# SCOPE TRACKING - ADDITIONAL WORK (TAW) - 16375

## SDD108A; 4Q2011 4 CRUDE MAJOR-EASTSIDE

V-1100 Level Gauge Piping Hitting Adjacent Deluge Piping

## **DELUGE PIPING MOD AT V-1100**

**SK-16375**

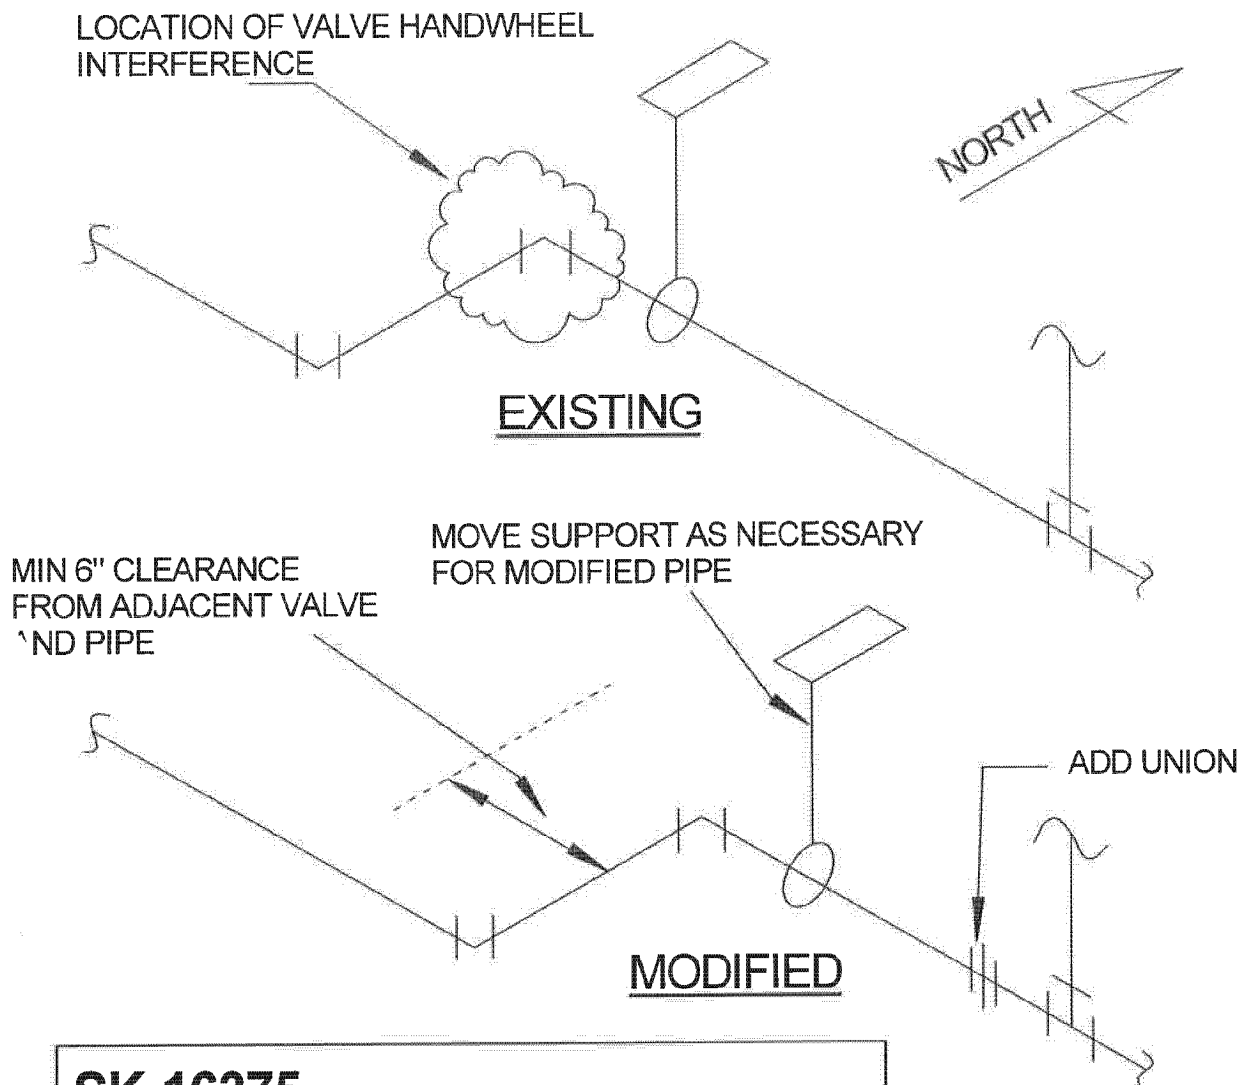
One of the valve handwheels on the replacement level bridle at V-1100 interferes with the adjacent deluge piping. Because the deluge piping is screwed galvanized pipe, it will be easier to modify the deluge piping than the bridle to eliminate the interference.

- \* MODIFY DELUGE PIPING AT V-1100 TO ELIMINATE INTERFERENCE WITH LEVEL BRIDLE VALVE HAND WHEEL.
- \* SEE ATTACHED P&ID D-330516 FOR LOCATION.
- \* PROVIDE AT LEAST 6" OF CLEARANCE BETWEEN DELUGE PIPING AND ADJACENT PIPING AND VALVES.
- \* MOVE PIPE SUPPORT SHOWN ON ABOVE SKETCH AS NECESSARY TO SUPPORT MODIFIED PIPE.
- \* FOLLOW PIPE CLASS 1CG11.
